original layout

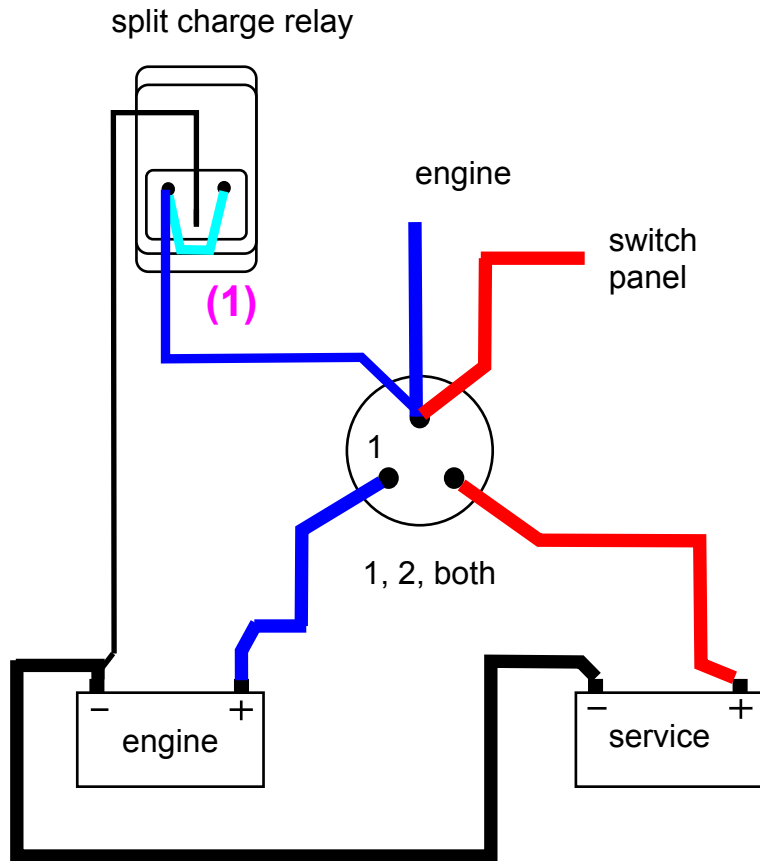
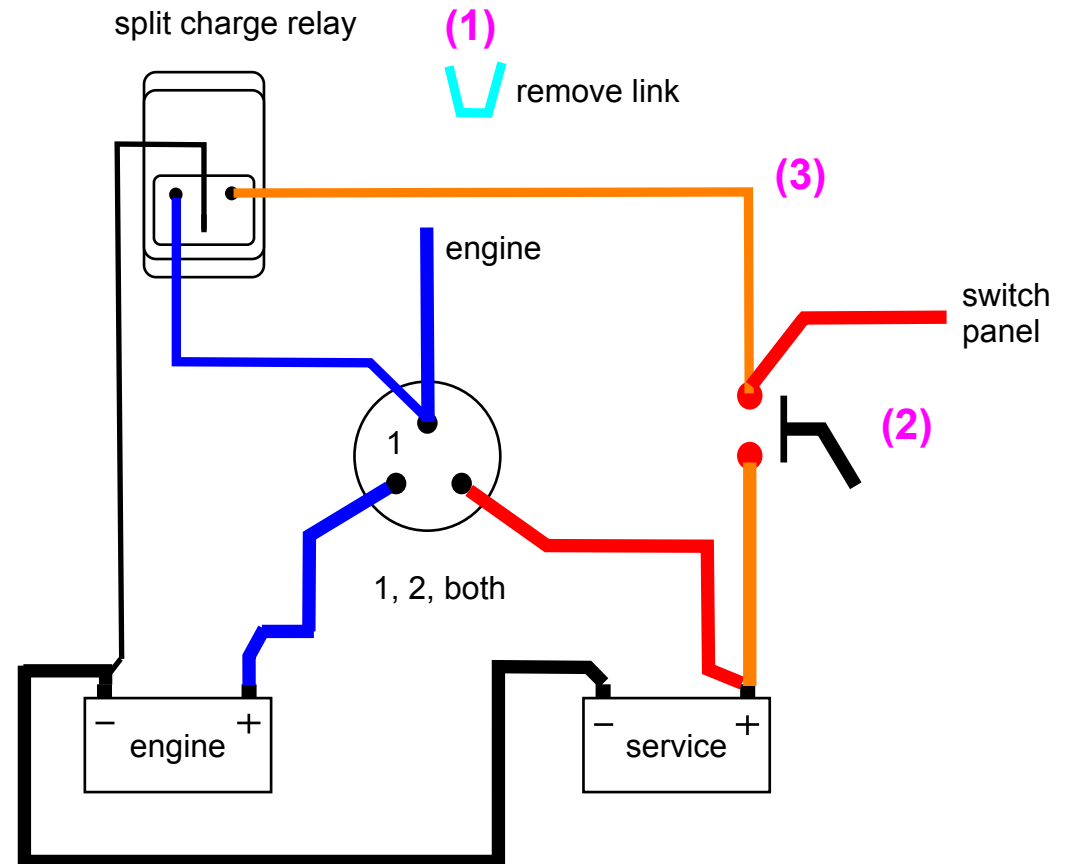
When built the boat should have been fitted with two isolator switches, one for engine supply, one for service power supply. A feed from each switch should have gone to the split charge relay, supplying feed to each voltage display and providing split charge.

Westerly fitted a 1,2 both switch in error and linked both terminals (1) on the split charge relay, This meant the split charge system did not work and the voltage display received incorrect voltage feed.

To correct the installation fit a new isolator (2) and fit a new link cable between isolator and service battery positive, using suitable size cable. Transfer feed to service loads from the 1,2,both switch to the new isolator.

Remove link (1) from the split charge relay and fit a new charge cable (3) of suitable size.

Position 1 feeds engine only

Position 2 allows links engine to service battery only.

Position both links all batteries for charge or starting.
